FACILITY OPERATING LICENSE NPF-30

CALLAWAY UPRATING SUBMITTAL
ATTACHMENT 3
ENVIRONMENTAL EVALUATION

CALLAWAY UPRATING SUBMITTAL
ATTACHMENT 4
SIGNIFICANT HAZARDS EVALUATION

CALLAWAY UPRATING SUBMITTAL

FIGURE 2.1-1
REACTOR CORE SAFETY LIMIT - FOUR LOOPS IN OPERATION

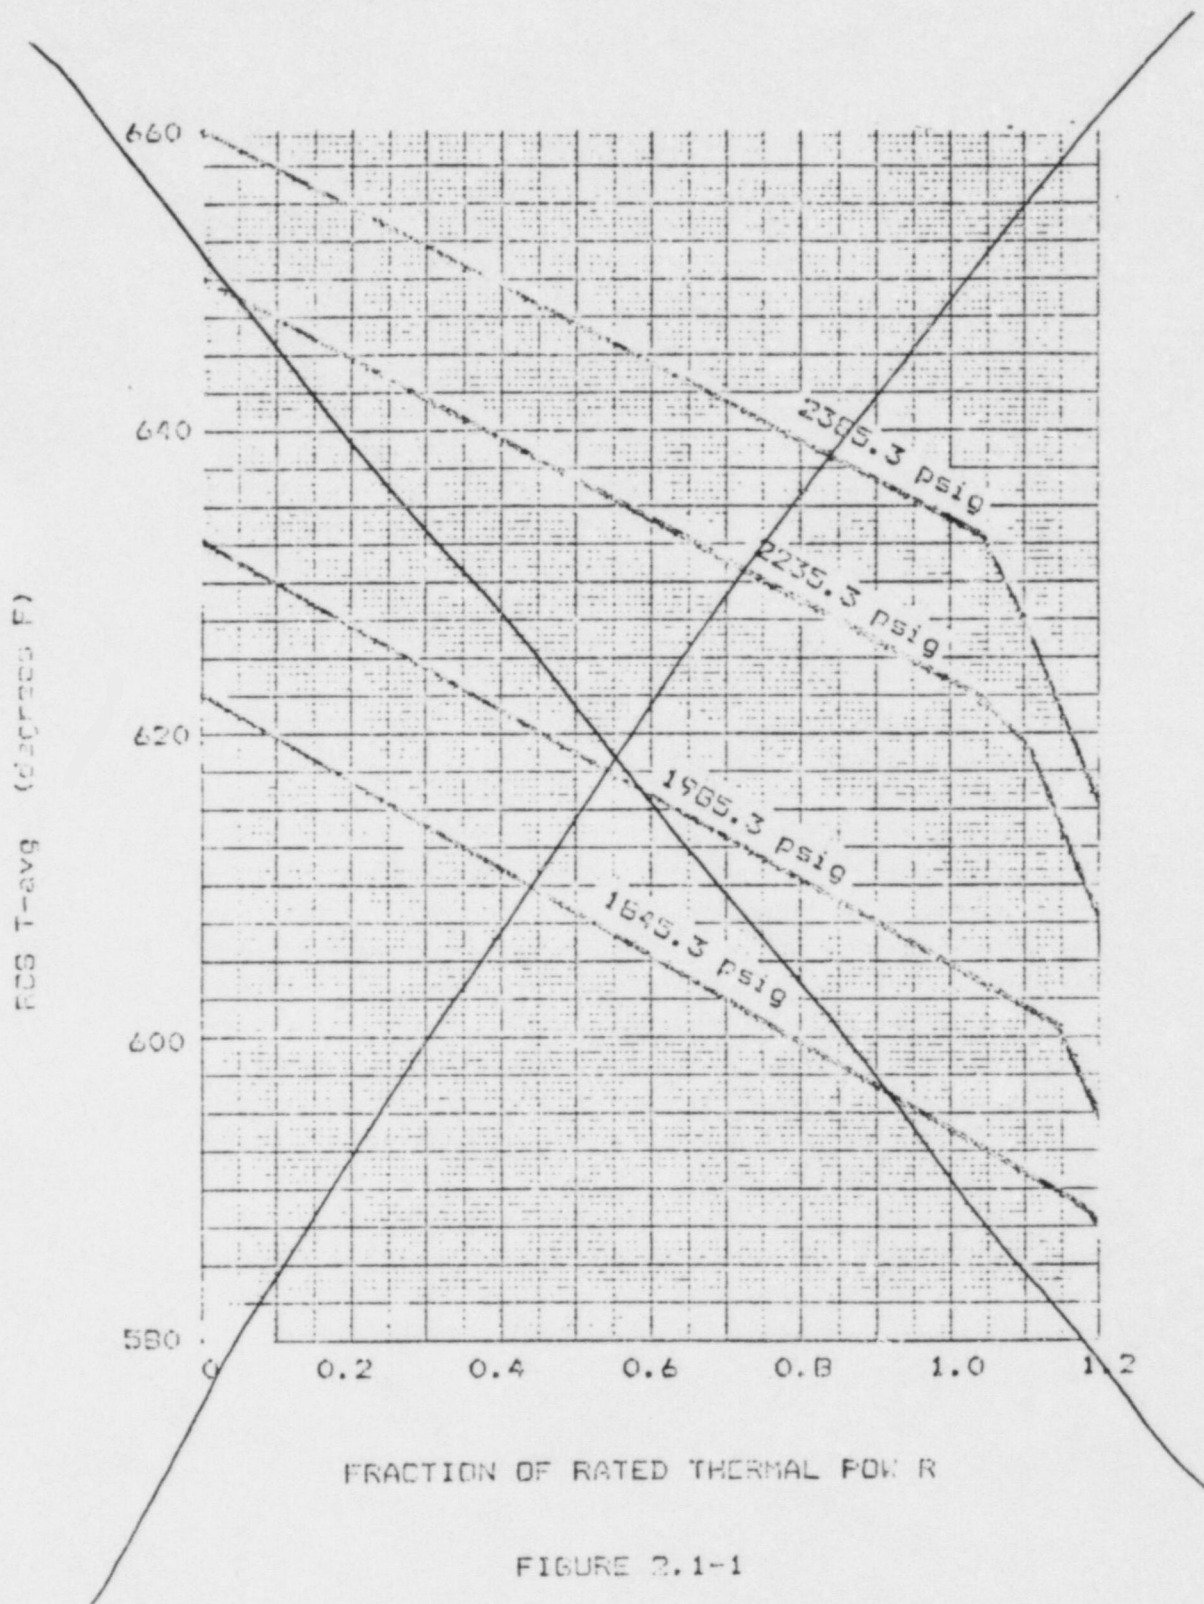
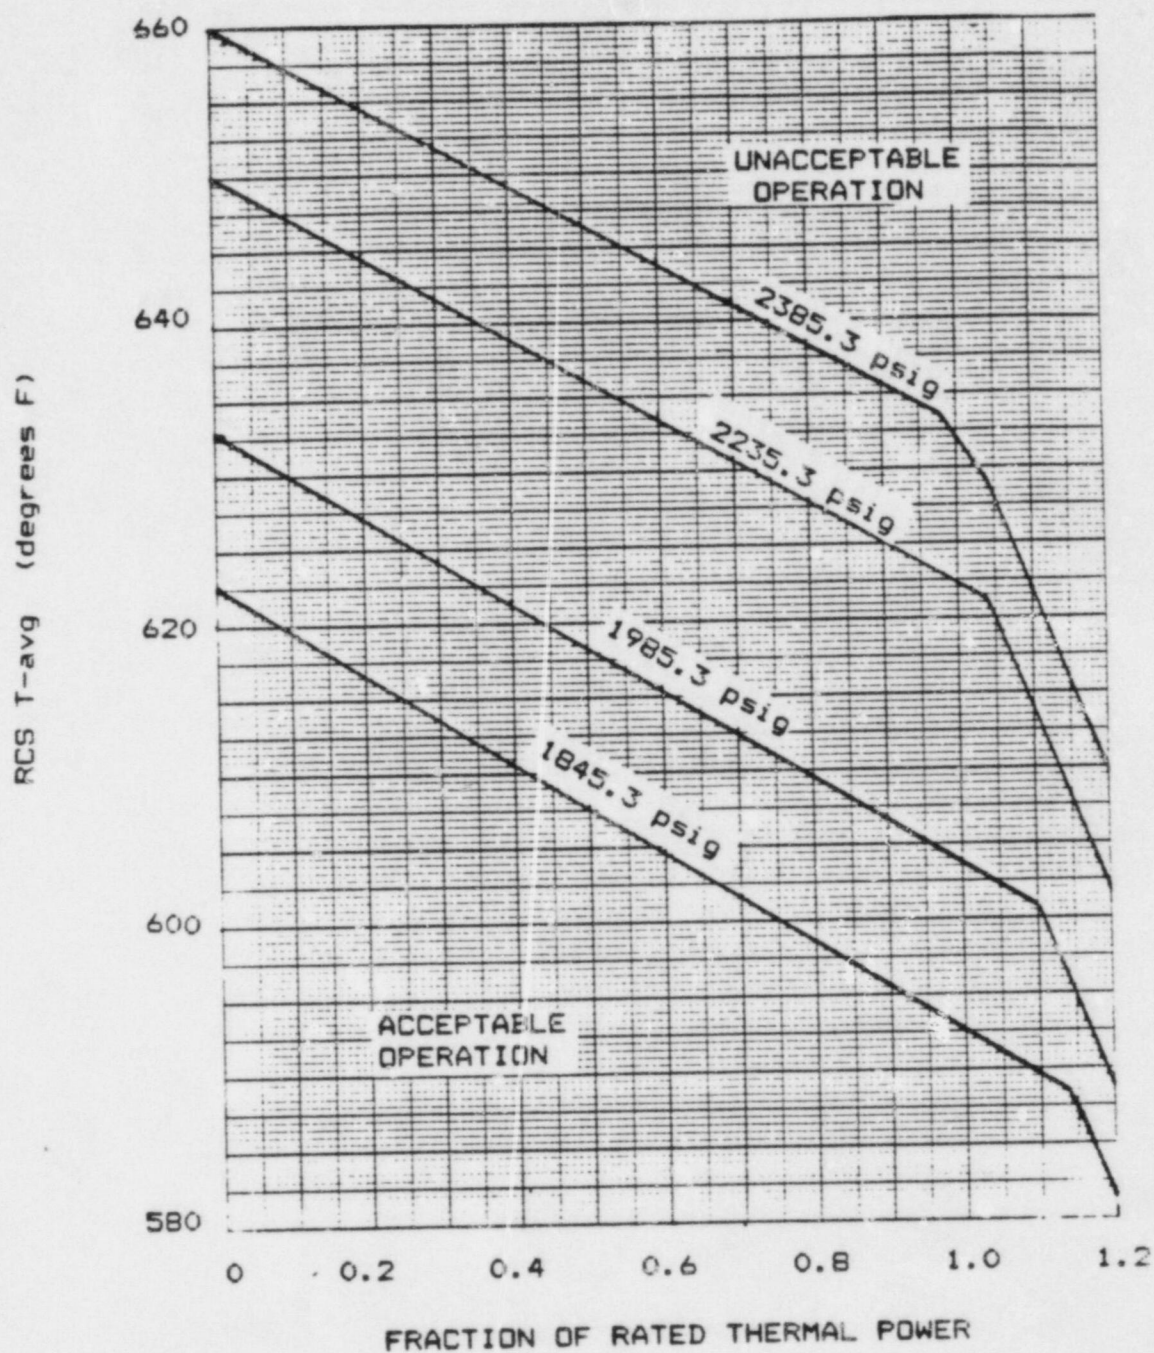
Replace with the following page

APPLICABLE FOR LICENSED CORE THERMAL POWER = 3565 MWe
